Fish Stream Survey Report

South Harris River Sale

Stream Name(ID) TROCADERO

11-4-77 (6 of 519)
UNIT-13
1 in 59

Harris River South
Unit 13
13.7 acres
1" = 500'

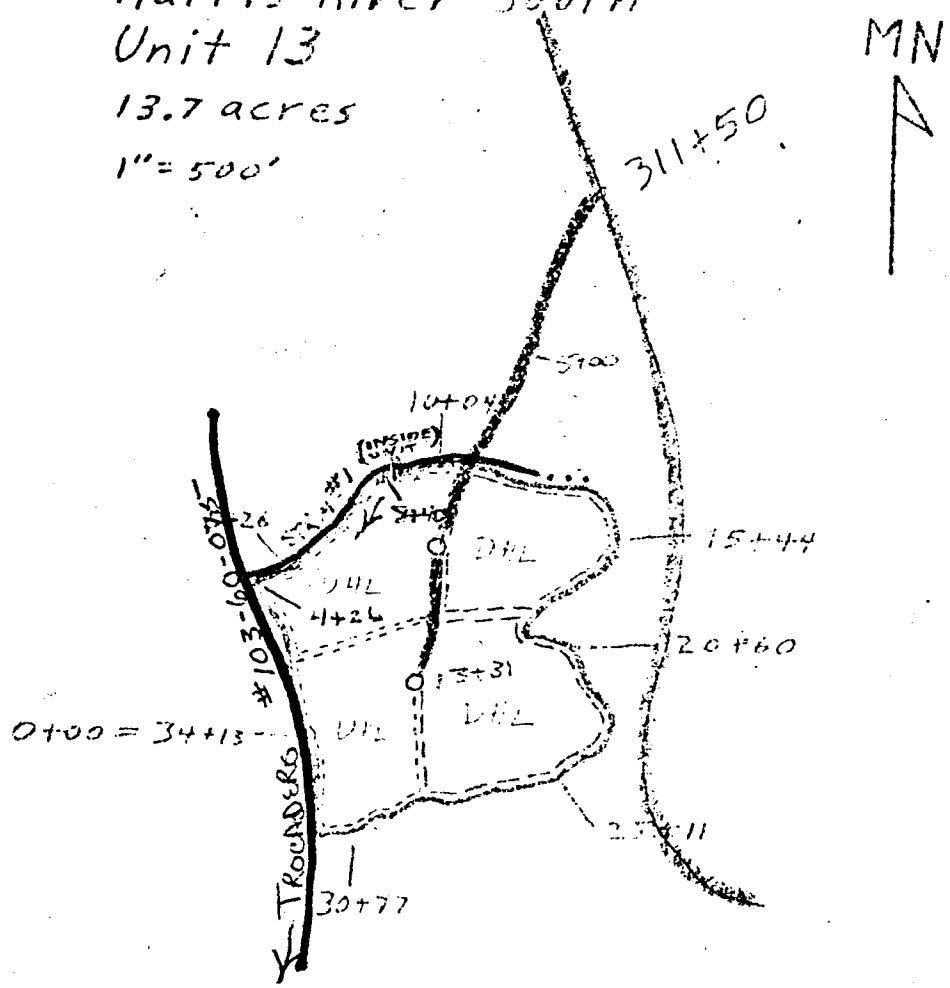
Comments: SOIL SHOULD BE CHECKED FOR STABILITY ALONG STREAM #103-60-075 (LEFT HEAD TROCADERO) & #1 BEFORE LOGGING OF UNIT 1
TROCADERO SHOULD BE GIVEN MAXIMUM PROTECTION INCLUDING FALLING & YARDING AWAY, AND 48 HOUR CLEAN UP OF SLASH. STREAM #1 (ALONG NORTH UNIT BOUNDARY) REQUIRES FALLING & YARDING AWAY, AND CHUNK CLEANING.

Recommendations: Directional falling to include lining, yarding away and 48 hr cleanup of all logging debris to above high water mark required for Trocadero, System is temp sensative. Leave as much undisturbed windfirm Non merch veg along Trocadero as possible, Do not exceed cutting guidelines for temp sen. streams. Directional falling and chunk cleaning Required for stream #1 - Split on or move unit boundary sout to stream #1 if possible. Suspension may be required over stream #1 to circumvent soils/fisheries/water quality problems - Soil Scientist input recommended - Mike
